STATE OF
COLORADO

Form 2A Review Marble-Redstone Doc# 402069851

While reviewing GMT's Marble-Redstone location, I came up with the following questions/BMPs to be addressed.

Table 4. Definitions for Group I, II, & III drilling fluids¹

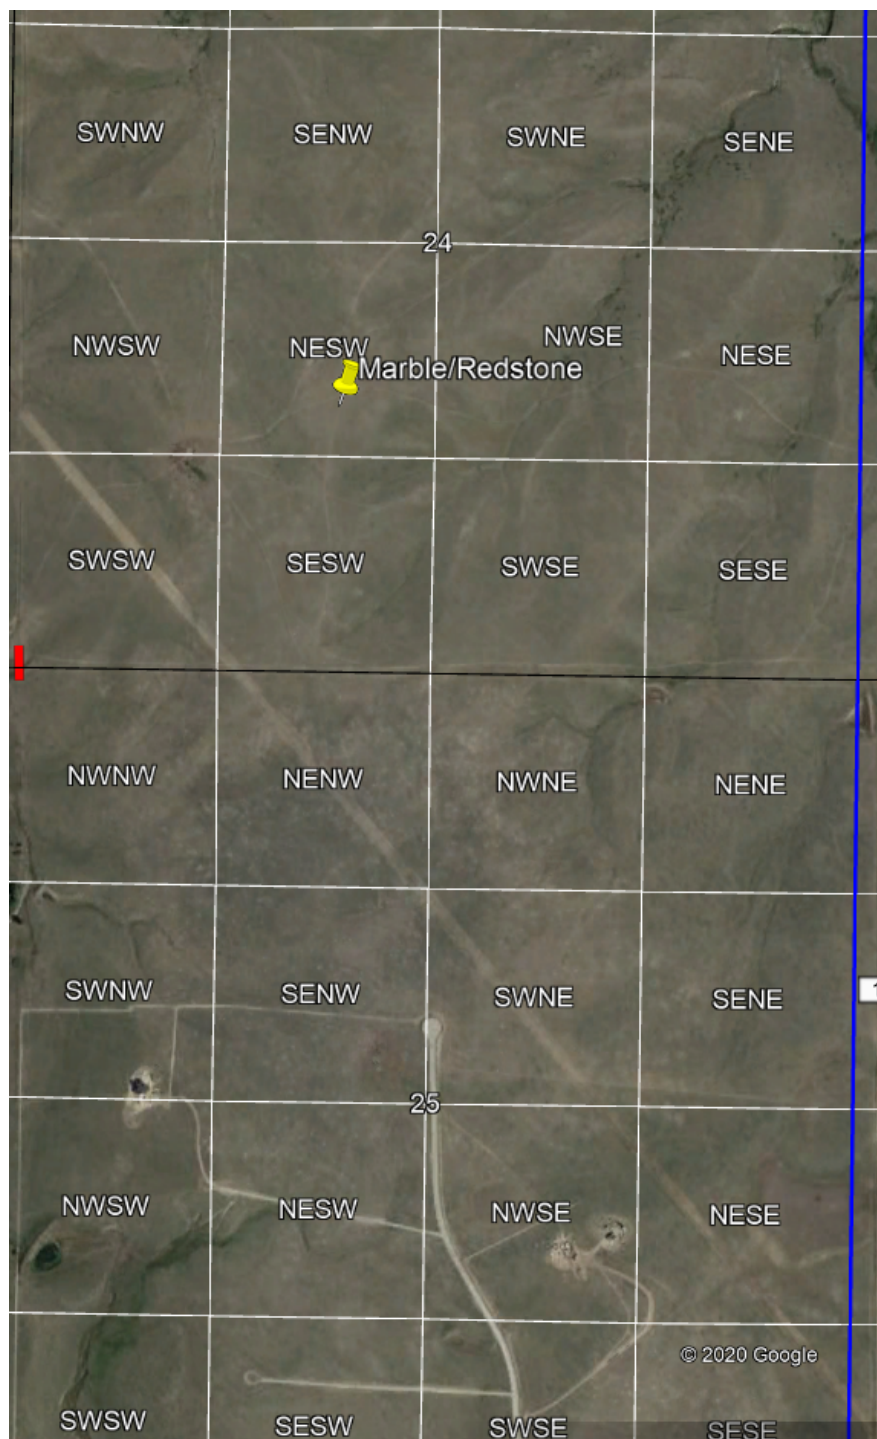
Going off of what is above, is it accurate to say that GMT uses a IPIECA Group II mud? If so, adding that a Group II mud is being used to the odor BMP is very beneficial and answer this question.

We are planning on using the Group (Catagory) II mud. I would include the following table:

Category	Components	Aromatic content
Group I: high-aromatic content fluids	Crude oil, diesel oil, and conventional mineral oil	5-35%
Group II: medium-aromatic content fluids	Low-toxicity mineral oil, distillate products	0.5-5%
Group III: low/negligible aromatic content fluids	Ester, LAO, IO, PAO, linear paraffin and highly processed mineral oil and synthetic oil	<0.5% and PAH lower than 0.001%
